SHIVANSH / ONGC BRRP | REPLACEMENT BRIDGE DRAWING BASIS

ICW - ICG LOWER DECK

Proposed document ID: SHV-BRRP-101-SK-001 | Rev P0 | 25 Oct 2026

SOW reference: B774-000-83-43-SOW-0001 Rev C, 6.1.1(c)-(d); uploaded PDF page(s) 42

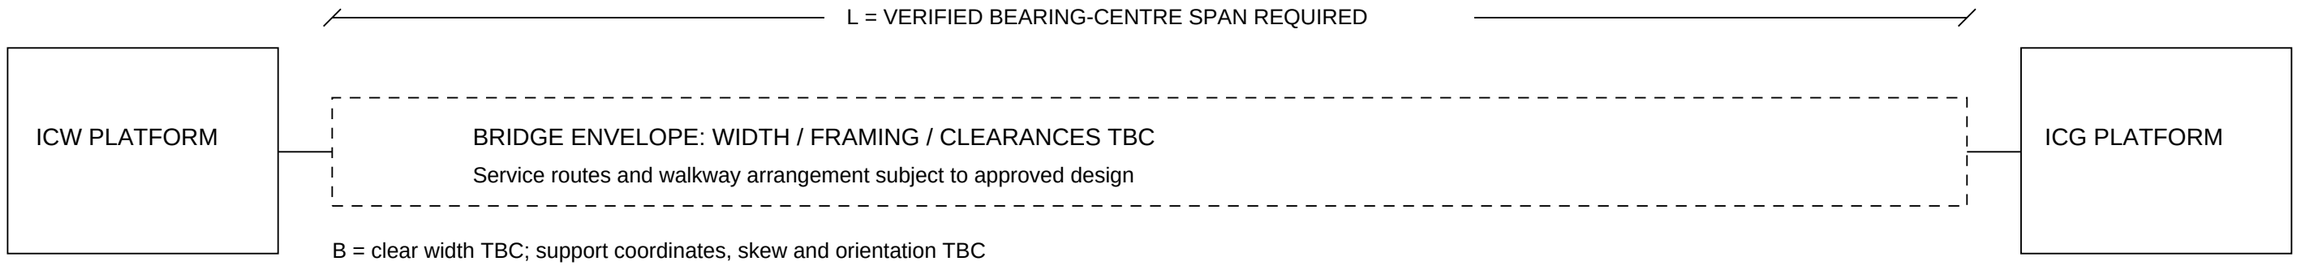
1. ICW landing modifications / extension: -0002 / -0003.
2. ICG landing modifications / extension: -0004 / -0005.
3. Include applicable ICG jacket strengthening from structural addendum.
4. SOW 6.1.3(e) calls the ICG-side work ICW strengthening: query location.

Tender register identifies B774-101-83-43-0001; narrative cites -83-41-0001. Drawing identity requires clarification.

ICP - ICG LOWER DECK

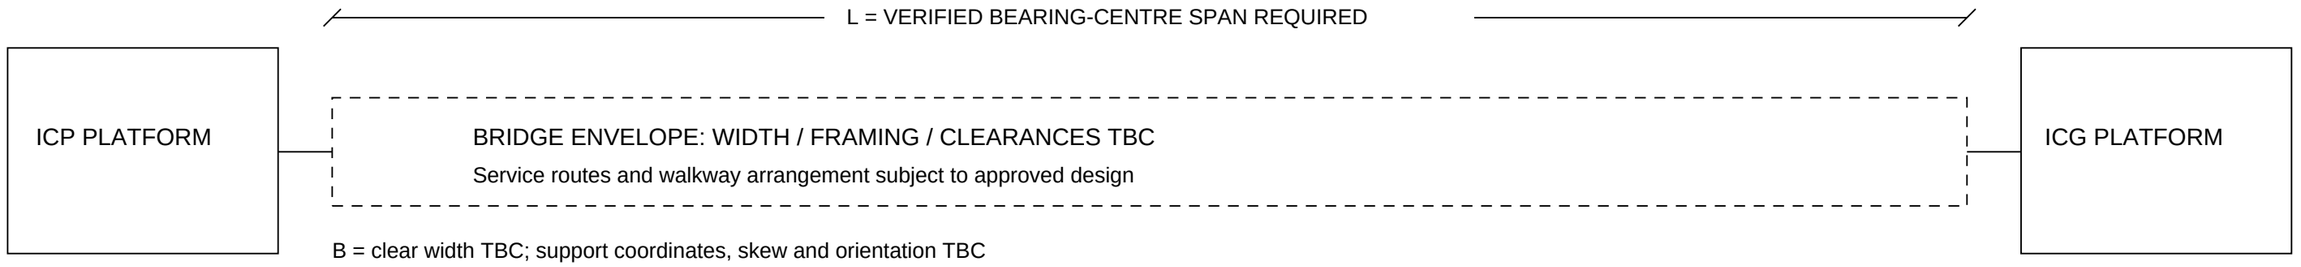
1. ICP landing modifications / extension: -0002 / -0003.
2. ICG landing modifications / extension: -0004 / -0005.
3. Include applicable ICP and ICG jacket strengthening from addendum.
4. Existing platform capacity, corrosion and reactions require verification.

Tender register identifies B774-102-83-43-0001; narrative cites -83-41-0001. Drawing identity requires clarification.

BHS - SLQ LOWER DECK

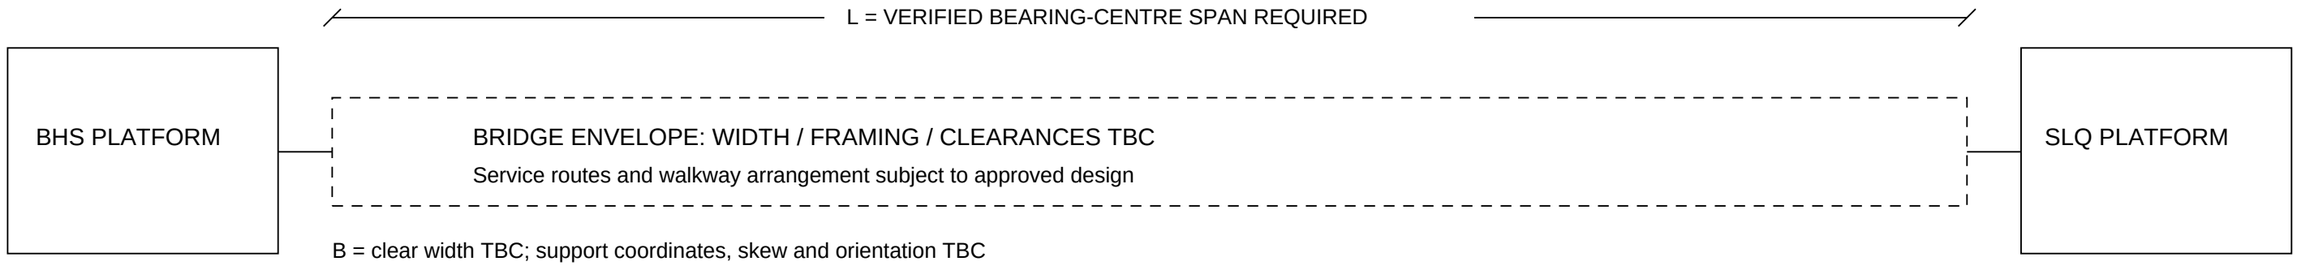
SLQ: TYPE UNRESOLVED - QUERY

1. SOW 6.3.1(c) says SLQ fixed; 6.3.3(f) says sliding: resolve before analysis.
2. BHS / SLQ landing modifications and extensions: -0002 through -0005.
3. Include piping/cables, cladding/roofing and applicable lifeboat interfaces.
4. New bridge and services accepted before existing bridge demolition.

Tender register identifies B774-103-83-43-0001; narrative cites -83-41-0001. Drawing identity requires clarification.
